DaimlerChrysler Corporation

Attached are copies of the slides that DaimlerChrysler presented yesterday, December 6, 2000, at the agency's Technical Workshop, held at VRTC in East Liberty, OH, regarding out-of-position test procedures for FMVSS 208. If there are any questions regarding the issues that were presented, please contact me at (248) 576-7303.

6 Year Old Positioning Issues
Position 1 and Position 2

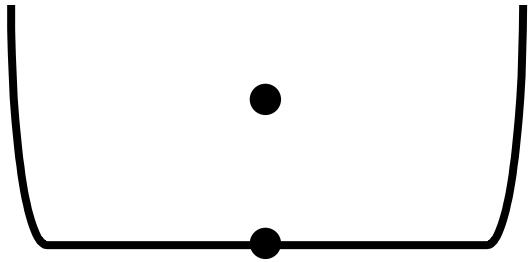
- In S24.4.1.2 - S24.4.1.3, Planes D and C are both defined relative to the “geometric center of the right front air bag tear seam.”
  - If the tear seam is “U” shaped, is the geometric center located on or above the seam?

- If the center of the “module” is above the tear seam, should the tear seam be used to determine the position of Plane C? (example - PT airbag door)

6 Year Old Positioning Issues
Position 1 - Chest on IP

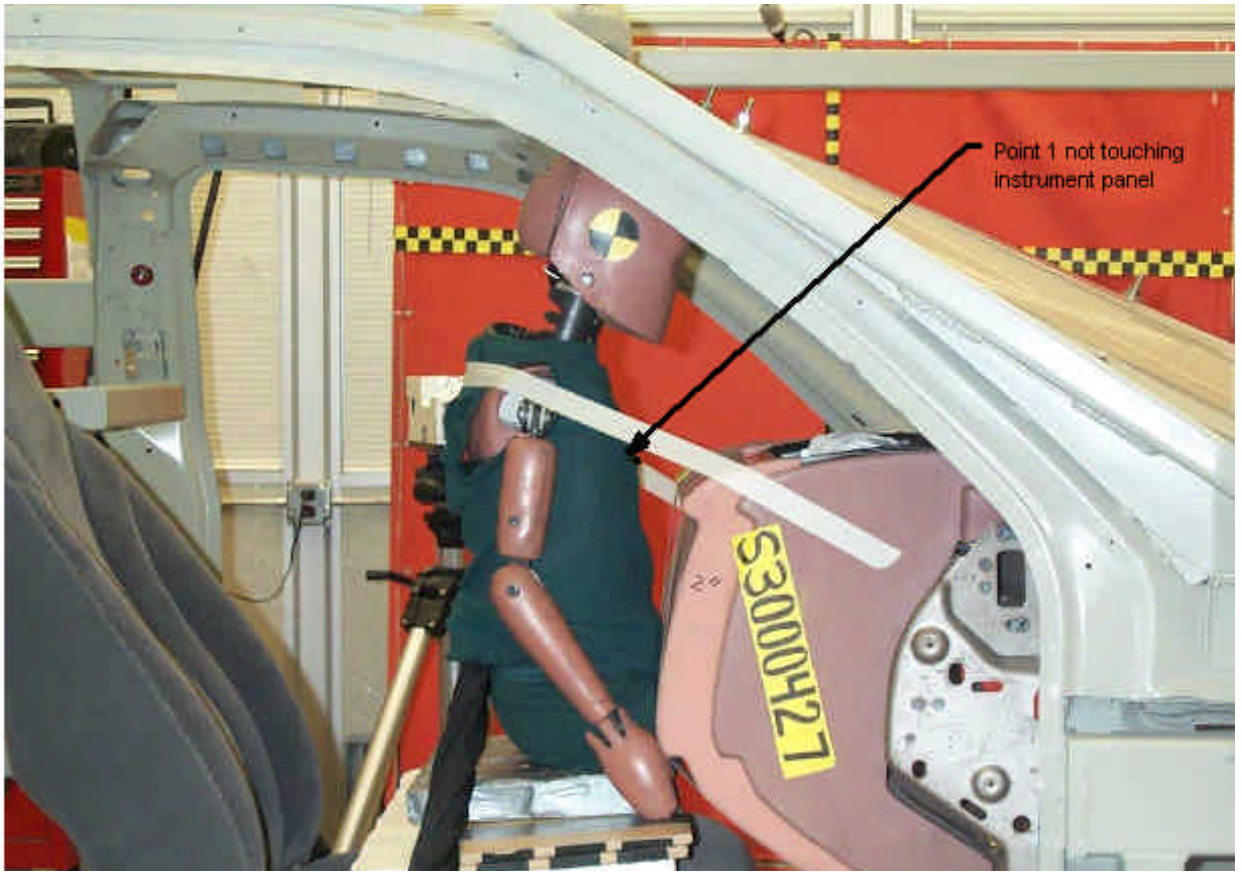
- Position 1: S24.4.2.4 states; “With the dummy's thorax instrument cavity rear face 6 degrees forward of the vertical and point 1 in plane C move the dummy forward until Point 1 contacts the instrument panel.”
  - In some cases Point 1 will not contact the instrument panel if the 6 degree angle requirement is maintained.
  - In this situation should the 6 degree angle be maintained or should point 1 be placed in contact with the instrument panel?
- A similar situation exists for the 3-year-old dummy (Section S22.4.2.4).

6 Year Old Positioning Issues
Position 2 - Head on IP

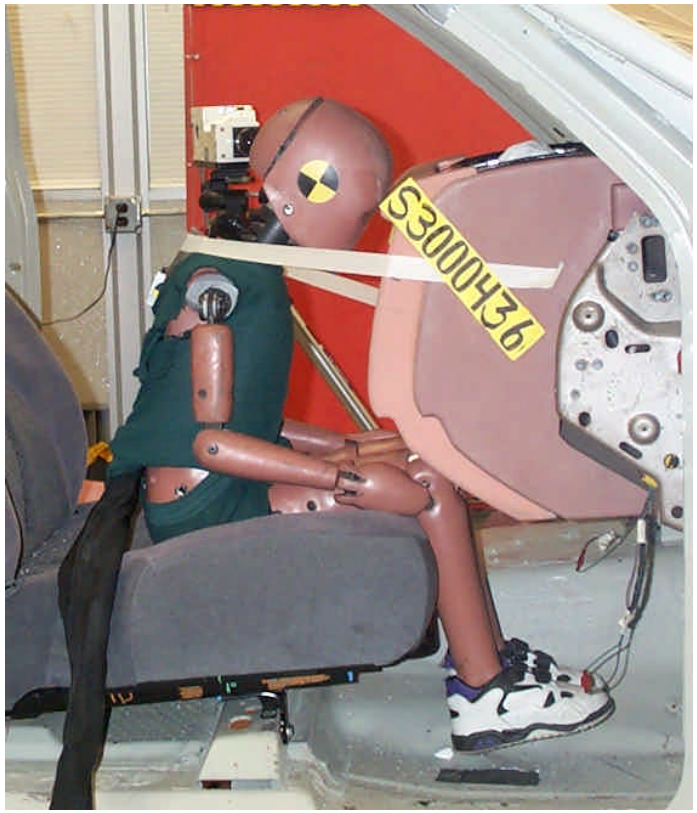
- Issue #2: S24.4.3.3 states; "Move the seat forward while maintaining the thorax instrument cavity rear face orientation until any part of the dummy contacts the vehicle's instrument panel."
  - If the knees of the dummy contact the instrument panel first, should the torso then be moved forward until the head or torso also contacts the instrument panel or should the torso be kept in the upright position away from the instrument panel?
  - Or, if sections S24.4.3.4 - S24.2.2.4.5 do not apply, do the subsequent two subsections still apply?
  - In short, should contact with the instrument panel be forced if the knees make contact before the chest or head of the dummy?

- To make contact with the IP, the back angle is increased.
